APPEAL SUMMARY

Appeal ID: 16052	Project Address: 4322 SE 28th Pl
Hearing Date: 11/1/17	Appellant Name: Robert Saladoff
Case No.: B-007	Appellant Phone: 5416019031
Appeal Type: Building	Plans Examiner/Inspector: Preliminary
Project Type: residential	Stories: 2 Occupancy: R Construction Type: V-NS
Building/Business Name: Johnson Remodel	Fire Sprinklers: No
Appeal Involves: Alteration of an existing structure	LUR or Permit Application No.:
Plan Submitted Option: pdf [File 1] [File 2] [File 3] Proposed use: living space

APPEAL INFORMATION SHEET

BASEMENT FLOOR PLAN

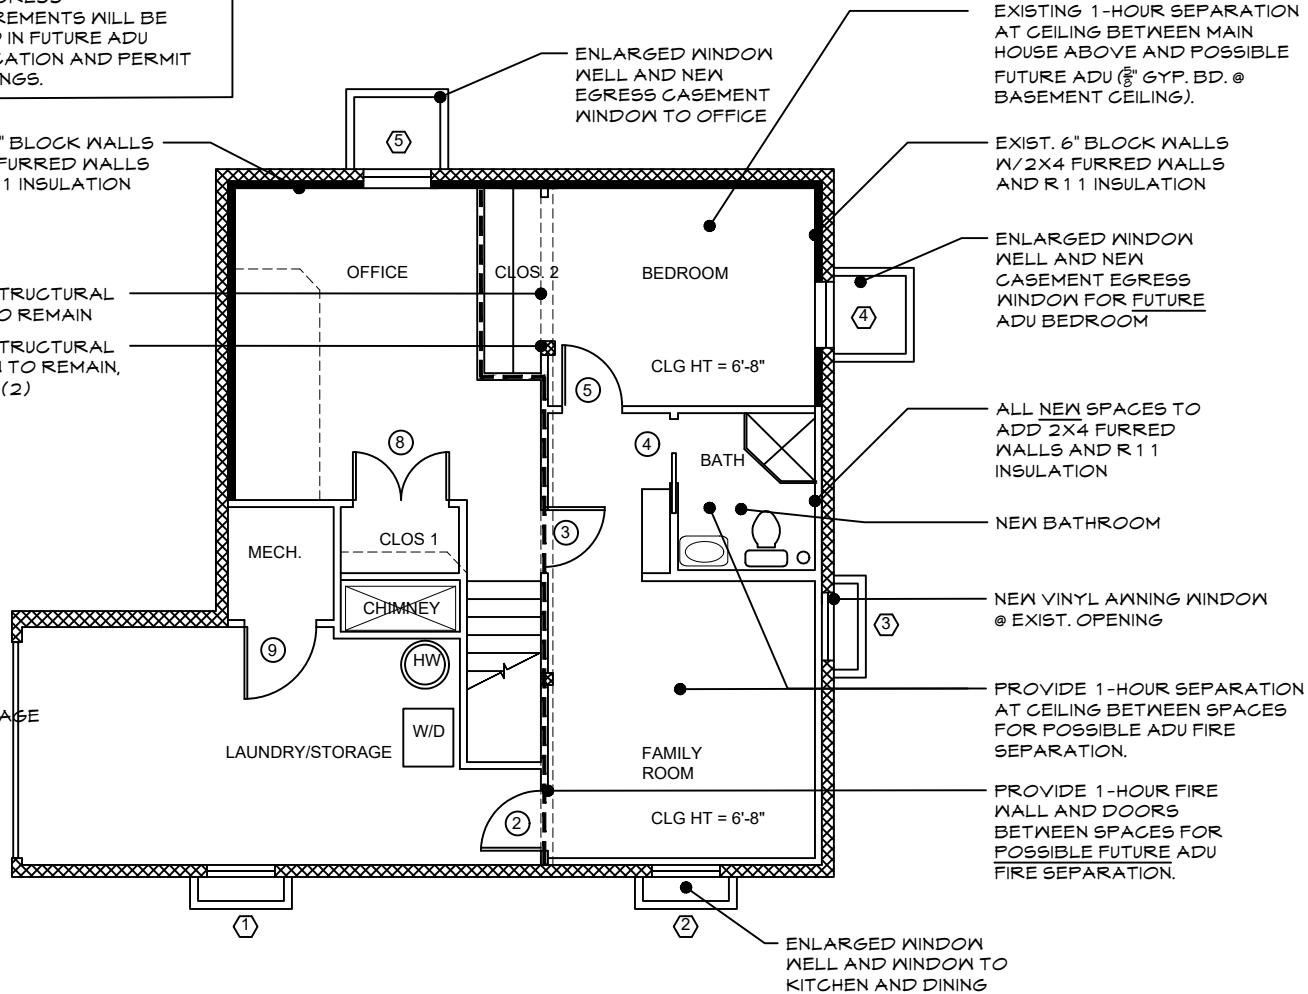
Code Section	2011 ORSC: R302.3 & BDS Program Guide: ADU - Section V.B.4a
Requires	<p>2011 Oregon Residential Specialty Code: R302.3 Two-Family Dwellings</p> <p>"Dwelling units in two-family dwellings shall be separated from each other by wall and/or floor assemblies having not less than a 1 hour fire resistance rating..."</p> <p>BDS Program Guide: Accessory Dwelling Units. Section V.B.4a: Separation Between Units</p> <p>Existing Conditions. b)Floor/Ceilings. A single wood floor with a ceiling of either wood lath and plaster or 1/2 inch gypsum wallboard, in sound condition, is acceptable.</p> <p>Construction of a new wall or floor ceiling. Where a new wall or floor/ceiling is constructed to create a separation between the units, such new wall of floor/ceiling shall be constructed to the one-hour fire resistive standards...</p>
Proposed Design	<p>The proposed project consists of a basement renovation in the existing house to provide additional living space.</p> <p>However, the owners would like to design and complete the renovation in a manner that allows for a possible ADU conversion and designation at a later time. To do so, they would like to provide the necessary one-hour fire separation between the future ADU and other living spaces- namely internal partition walls and ceiling above. This appeal deals only with the separation vertically between the basement and upper first floor.</p> <p>The existing first floor assembly will be used to provide the required separation between the existing dwelling and any potential new ADU in the basement. The existing floor assembly consists of 2x8 wood joists spaced at 16 inches on center with a 1/2 x 4 subfloor and 1x tongue and groove solid wood flooring on top. To provide adequate fire separation it is proposed that the existing floor</p>

assembly be upgraded by adding additional materials to the underside and between the joists so the resulting assembly closely matches the 1-hour assembly provided Gypsum Association File No. FC 5120, without replacing the existing floor system. The proposed system includes one layer of 5/8" type "x" gypsum board, resilient furring channels 24" o.c., and 3 1/2 inches of glass fiber insulating batts installed in each joist cavity.

Reason for alternative In areas of the basement with exposed ceilings (see plans), the existing floor assembly does not meet the exact minimum code per BDS/ADU Program Guide which requires a minimum of 1/2" gypsum board applied to the underside of the floor system. Removing the existing and constructing a new floor assembly is not structurally or financially feasible and it is proposed that the existing floor system be upgraded to meet acceptable code standards.

All tested 1-hour fire rated ceiling assemblies in new construction would require 2x10 or large wood floor joists as no tested assemblies allow 2x8 wood floor joists. It is therefore proposed, that the existing floor assembly be upgraded to approximate GA FC 5120, but goes beyond the minimum gypsum board requirements using 5/8" type "x" gypsum board instead of 1/2". The proposed assembly approximates the tested FC 5120 assembly and exceed the performance set by BDS/ADU Program Guide.

See the attached plan, building section and proposed floor/ceiling assembly for more information.

The existing first floor assembly will be used to provide the required sound separation between the existing dwelling and any potential new ADU in the basement. The existing floor assembly consists of 2x8 wood joists spaced at 16 inches on center with a 1/2 x 4 subfloor and 1x tongue and groove solid wood flooring on top. To provide adequate sound separation it is proposed that the existing floor assembly be upgraded by adding additional materials to the underside and between the joists so the resulting assembly closely matches the sound insulation provided Gypsum Association File No. FC 5120, without replacing the existing floor system. The proposed system includes one layer

of 5/8" type "x" gypsum board, resilient furring channels 24" o.c., and 3 1/2 inches of glass fiber insulating batts installed in each joist cavity.

Reason for alternative Section V.B.4.a for Separation Between Dwelling Units in the BDS ADU Program Guide indicates that it is not required to provide sound separation in existing buildings especially when the separation assemblies are existing and achieving sound separation in older homes is often physically and financially impractical. In addition, there is not a current sound tested assembly when using only 2 x 8 floor joists.

In areas of the basement with exposed ceilings (see plans), the proposed assembly should provide additional sound insulation and impact rating beyond what now exists. Removing the existing and constructing a new floor assembly is not structurally or financially feasible and it is proposed that the existing floor system be upgraded to meet acceptable code standards.

Also, all tested sound rated ceiling assemblies in new construction would require 2x10 or large wood floor joists as no tested assemblies allow 2x8 wood floor joists. It is therefore proposed, that the existing floor assembly be upgraded to approximate GA FC 5120, but go beyond the minimum gypsum board requirements using 5/8" type "x" gypsum board instead of 1/2". The proposed assembly approximates the tested FC 5120 assembly with an STC rating of 50 and IIC rating of 45 and exceed the performance set by BDS/ADU Program Guide.

See the attached plan, building section and proposed floor/ceiling assembly for more information.

1. Alternate one hour assembly based on GA FC 5120 for horizontal separation between ADU and primary unit: No appeal required.

2. Alternate STC / IIC sound assembly based on GA FC 5120 for horizontal separation between ADU and primary unit: No appeal required.
